DUKE POWER COMPANY
DESCRIPTION OF PROPOSED MODIFICATIONS
for
GENERIC LETTER 89-19

OCONEE NUCLEAR STATION

STEAM GENERATOR DRYOUT PROTECTION
'SGDO'

STEAM GENERATOR OVERFILL PROTECTION
'SGOP'

FIGURE 4

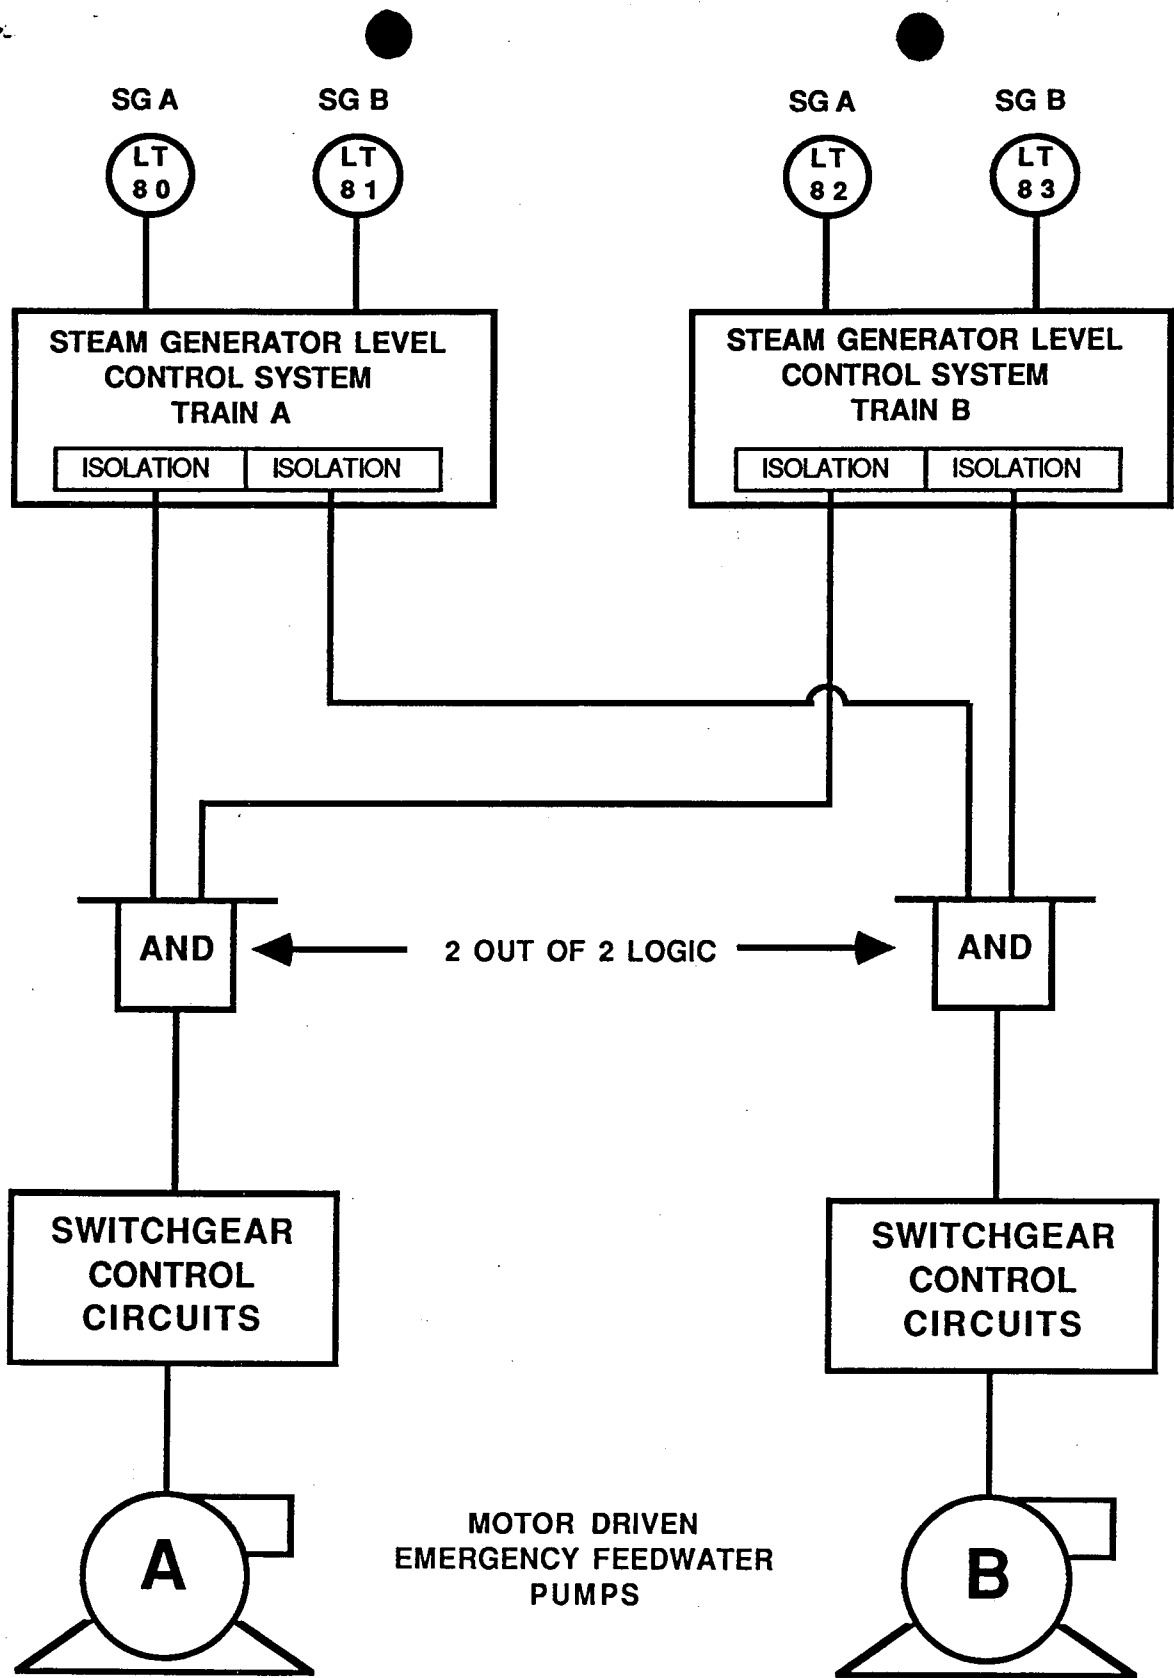
These level signals will be used to start the MDEFWP's upon 2 out of 2 low OTSG level. Isolated outputs from the SGLCS will be arranged such that if low level is sensed in either OTSG both MDEFWP's will start and provide water to both steam generators as controlled by the same level transmitters. At the same time as the pumps are commanded to start, the level control system will be directed to control level to the appropriate set point depending upon whether any Reactor Coolant Pumps are running. Computer alarms will be provided to alert the operator to initiation of EFW due to low OTSG levels and to serve as a record for transient event evaluation.

A 30 second time delay (adjustable) is expected to be used upon indication of 2 out of 2 low level in either steam generator to distinguish between transitory level swings during post trip conditions and true low level situations. The initiation level set point and the time delay will be prudently selected such that inadvertent starts of EFW and the resulting additional operator burdens are minimized.

Rosemount 1154 transmitters are used to determine OTSG level for the SGLCS. Because of the dynamics of measuring level in the OTSG's, it will be necessary to install noise filtering methodologies to improve signal quality for initiating EFW on low OTSG level. The techniques employed may be of both a mechanical nature (snubbers in the impulse lines) and an electrical nature (noise filters).

Figure 4 shows a functional block diagram of the proposed SGLCS initiation of EFW on low OTSG level.

FIGURE 6

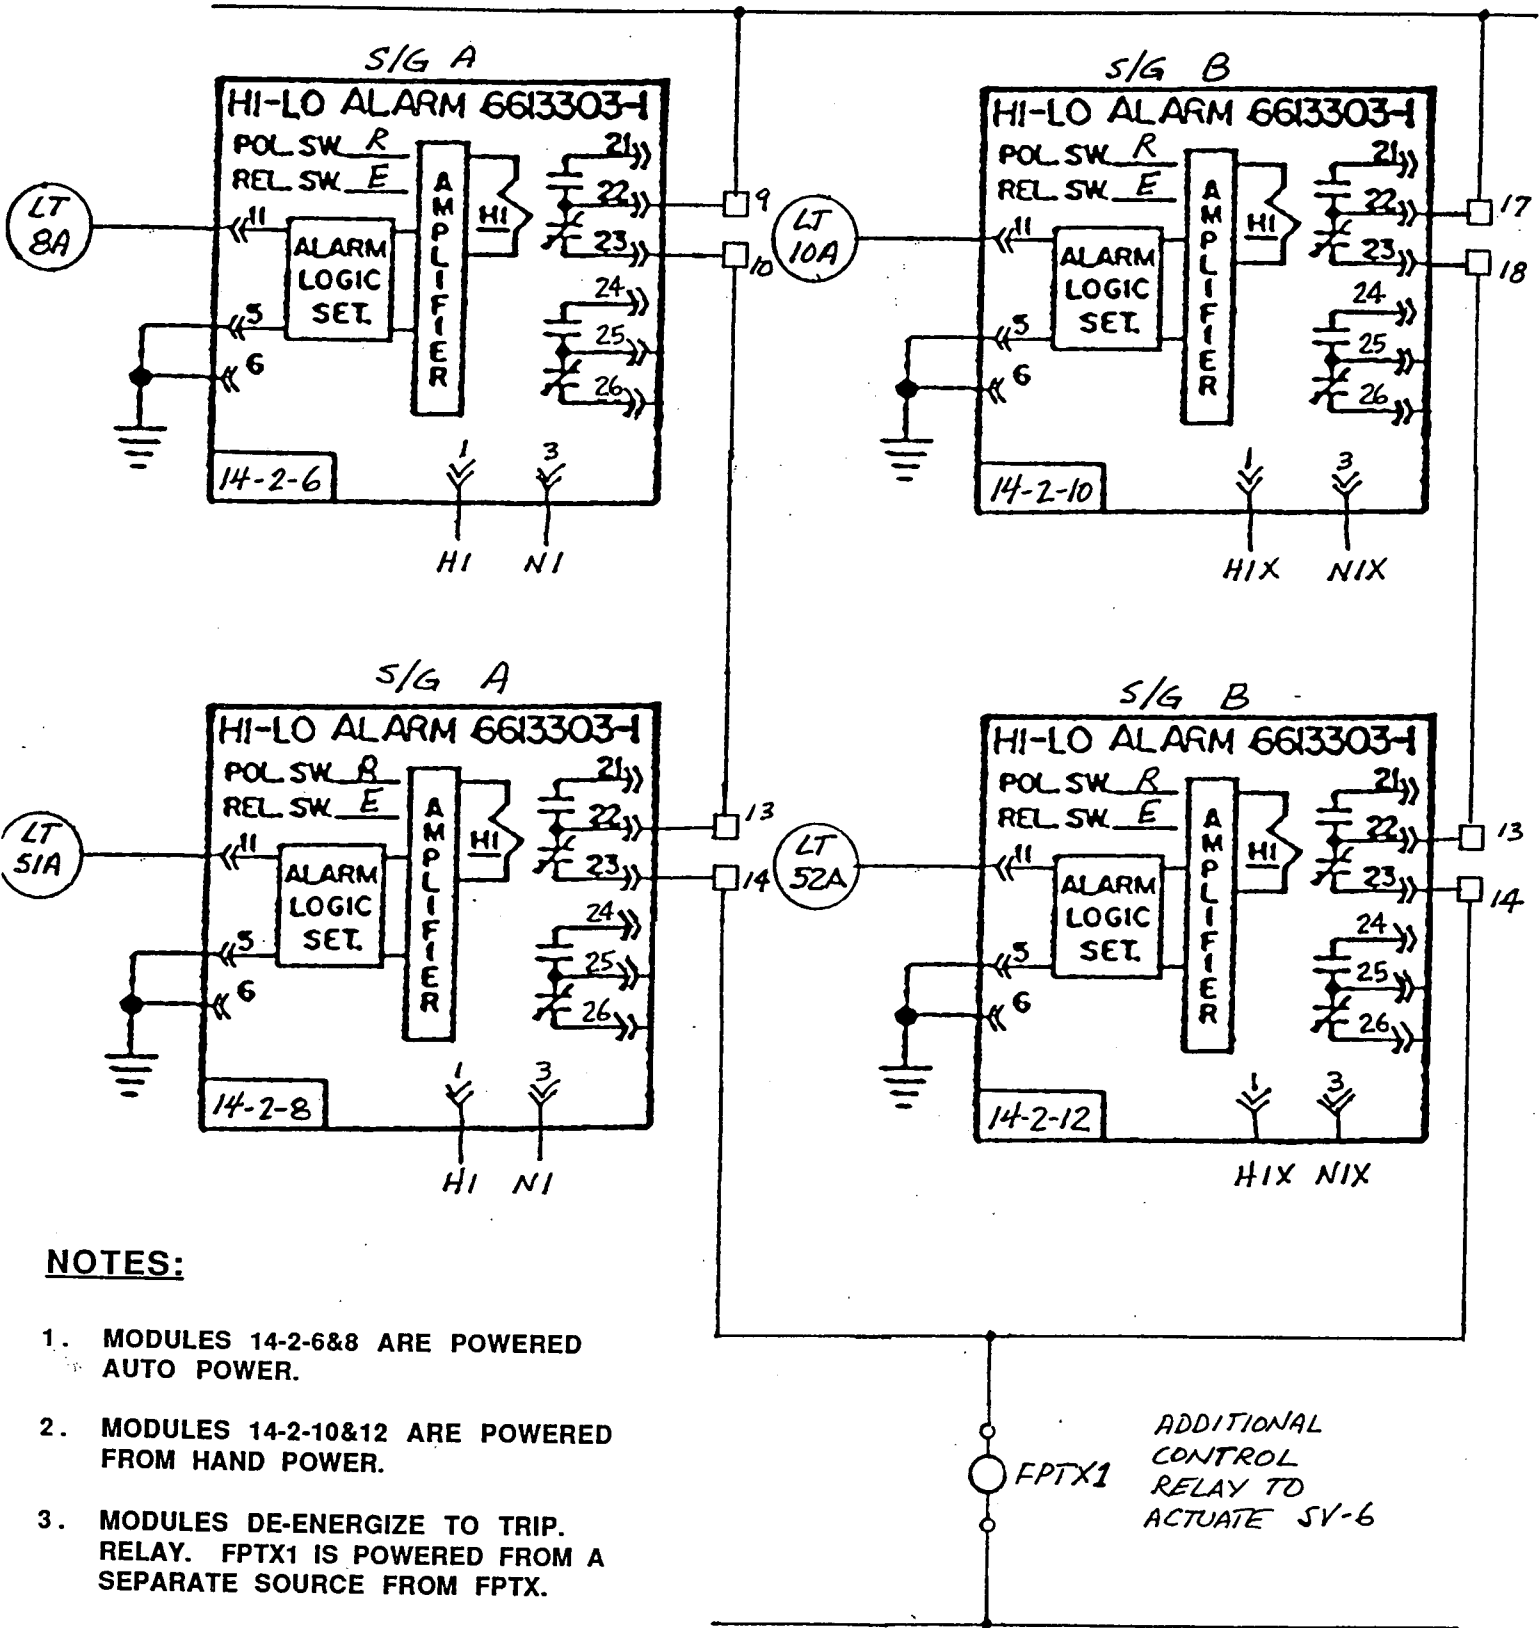
The main feedwater pump turbine trip circuits will be modified to utilize an additional trip device to assure that the turbine trips when required. Solenoid valve SV6 will be connected to the existing steam generator level monitors on separate contacts. These contacts are presently used to trip the main turbine. This modification will add an auxiliary relay to trip both pieces of equipment.

See Figure 6 for a simplified electrical circuit showing the proposed modifications to the level monitoring circuits.

FIGURE 7

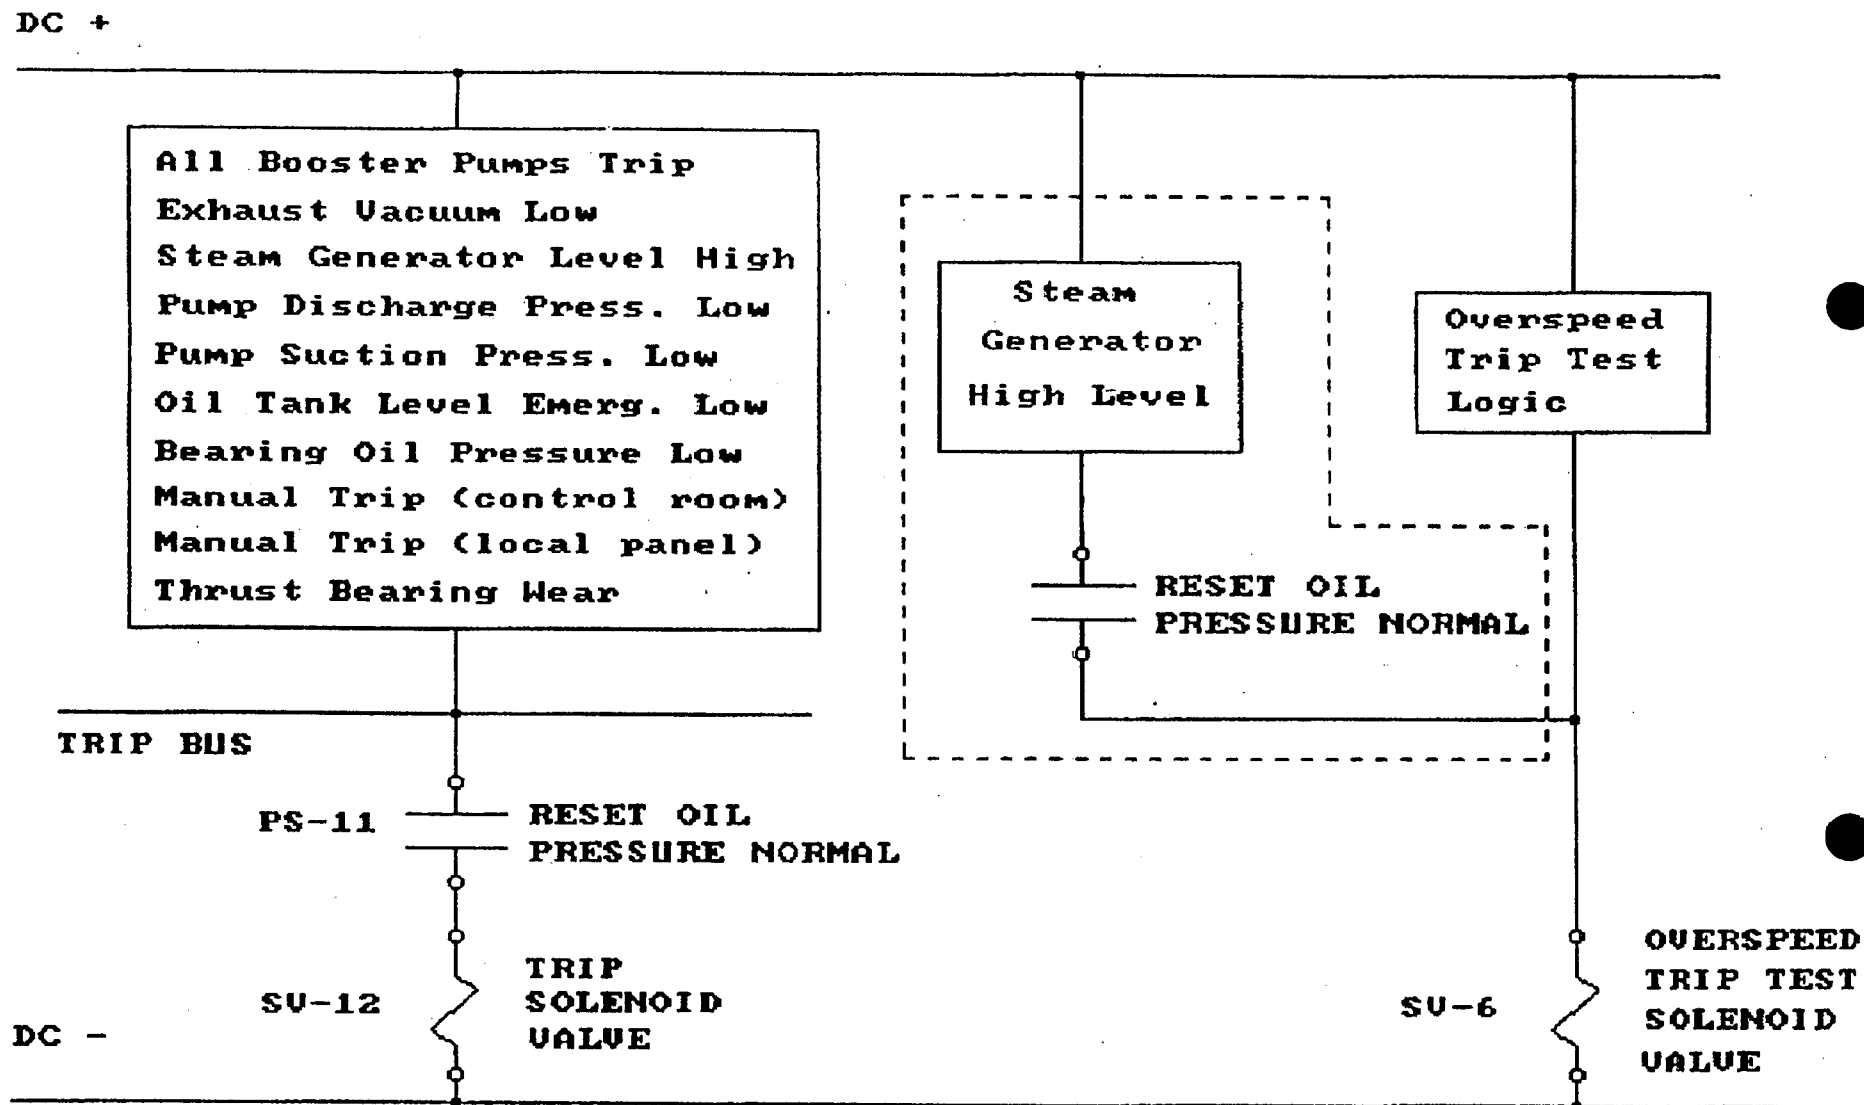
See Figure 7 for a simplified electrical circuit showing the proposed modifications to the feedwater pump trip circuits.

The power sources for the existing feedwater pump turbine trip device (SV12) is from the non-safety grade 125VDC station power batteries. The additional trip device (SV6) will also be powered from this source. The power source for the auxiliary relay to be added for actuating SV6 will be from the 125VDC station instrumentation and control batteries.

FIGURE 8
MAIN FEEDWATER
PUMP TURBINE
CONTROL OIL
DIAGRAM

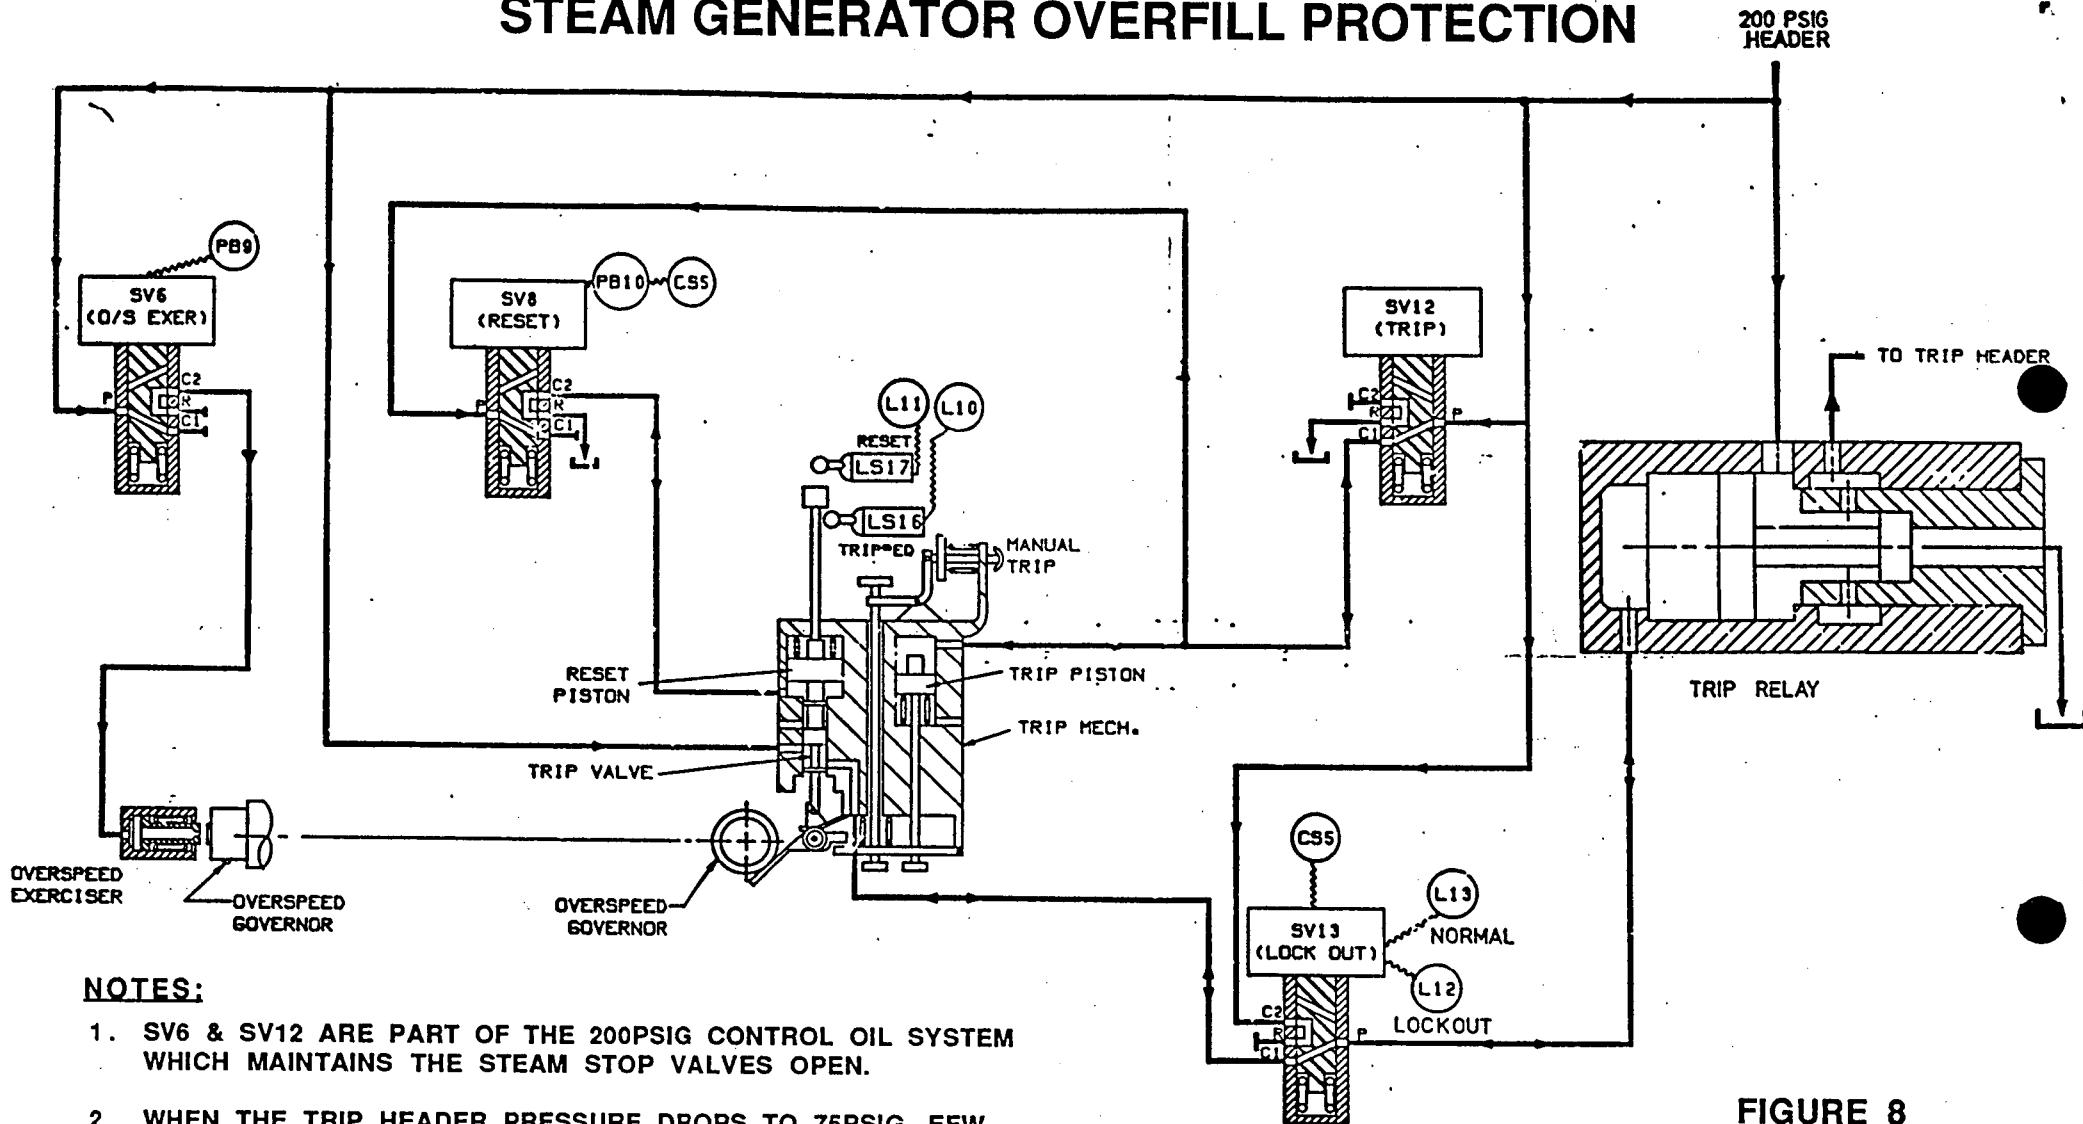
See Figure 8 for a simplified hydraulic oil circuit which show the feedwater pump turbine trip device relationships.

1. SV6 & SV12 ARE PART OF THE 200PSIG CONTROL OIL SYSTEM WHICH MAINTAINS THE STEAM STOP VALVES OPEN.
2. WHEN THE TRIP HEADER PRESSURE DROPS TO 75PSIG, EFW WILL BE INITIATED.
3. THE OVERSPEED EXERCISER IS TESTED WEEKLY AS PART OF NORMAL FEEDWATER PUMP TURBINE MAINTENANCE.
4. SV13 IS INTERLOCKED THRU SV12 VIA INTEGRAL N.C. CONTACTS SO THAT SV13 CAN'T PREVENT A TRIP. THE ADDITION OF SV6 FOR GL 89-19 ASSURES PUMP TRIP.
